Access Compliance Report

Public Rights-of-Way

(Pedestrian Signals)

Intersection ID: N/A	Main Street:	Cross Street: N/A	Location: N/A
ADA ID: 40EA1C98C39C	Signal Type: One Push Button-Non APS	Overall Compliance: No	Severity Score: BTN 1: N/A BTN 2: N/A No BTN: N/A
Codes/Mitigation Info/Possible Solution		Field Measurements/Component Compliance

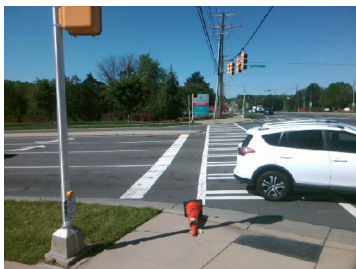
PROW/ADA: TMUTCD 4e.08, R404.2, R406.2

Compliance	Description	Data	Compliance	Description	Data
	Button Count	Button1	Yes	Distant to Additional Button (in)	351.0
	Additional Button Present?	Yes		Additional Button ID	100F52BF5A8D
N/A	Signal Buttons Required?	N/A	N/A	Additional Ped Posts Required	N/A
	How Many Ped Street Xings?	1		Located In An Island/Median?	No
N/A	B 1 Sign Present?	Yes	N/A	B 2 Sign Present?	N/A
Yes	B 1 Sign Purpose?	Yes	N/A	B 2 Sign Purpose?	N/A
Yes	B 1 Sign Lettering & Contrast?	Yes	N/A	B 2 Sign Lettering & Contrast?	N/A
Yes	B 1 Parallel To XWalk?	Yes	N/A	B 2 Parallel To XWalk?	N/A
Yes	B 1 PAR to Button?	Yes	N/A	B 2 PAR to Button?	N/A
Yes	B 1 PAR to XWalk?	Yes	N/A	B 2 PAR to XWalk?	N/A
Yes	B 1 Clear Floor Space?	Yes	N/A	B 2 Clear Floor Space?	N/A
N/A	B 1 FWD Approach?	Yes	N/A	B 2 FWD Approach?	N/A
N/A	B 1 FWD Approach Constrained?	No	N/A	B 2 FWD Approach Constrained?	N/A
No	B 1 FWD Approach Reach (in)	8.0	N/A	B 2 FWD Approach Reach (in)	N/A

N/A	B 1 FWD Approach Width (in)	N/A	N/A	B 2 FWD Approach Width (in)	N/A
N/A	B 1 FWD Approach Obstruction?	Yes	N/A	B 2 FWD Approach Obstruction?	N/A
N/A	B 1 FWD Approach Obstruction Dist (in)	6.0	N/A	B 2 FWD Approach ObstructionDist (in)	N/A
N/A	B 1 PARA Approach?	Yes	N/A	B 2 PARA Approach?	N/A
N/A	B 1 PARA Approach Constrained?	No	N/A	B 2 PARA Approach Constrained?	N/A
Yes	B 1 PARA Approach Reach (in)	8.0	N/A	B 2 PARA Approach Reach (in)	N/A
N/A	B 1 PARA Approach Width (in)	N/A	N/A	B 2 PARA Approach Width (in)	N/A
N/A	B 1 PARA Approach Obstruction?	Yes	N/A	B 2 PARA Approach Obstruction?	N/A
N/A	B 1 PARA Approach Obstruction Dist (in)	6.0	N/A	B 2 PARA Approach ObstructionDist (in)	N/A
Yes	B 1 Clear Floor Space Slope (%)	2.1	N/A	B 2 Clear Floor Space Slope (%)	N/A
No	B 1 Clear Floor Space XSlope (%)	3.3	N/A	B 2 Clear Floor Space XSlope (%)	N/A
N/A	B 1 PAR Slope (%)	5.7	N/A	B 2 PAR Slope (%)	N/A
Yes	B 1 Height (in)	36.0	N/A	B 2 Height (in)	N/A

Yes	B 1 Clear Xing Direction?	ClearlyMarked	N/A	B 2 Clear Xing Direction?	N/A
	B 1 Crossing Direction	To SW		B 2 Crossing Direction	N/A
No	B 1 DistanceTo XWalk (in)	63.0	N/A	B 2 DistanceTo XWalk (in)	N/A
No	B 1 DistanceTo Curb (in)	90.0	N/A	B 2 DistanceTo Curb (in)	N/A
Yes	B 1 Diameter (in)	2.0	N/A	B 2 Diameter (in)	N/A

Possible Solutions: Replace Signal Push Button With APS Button on New Post. Remove & Relocate Sign.
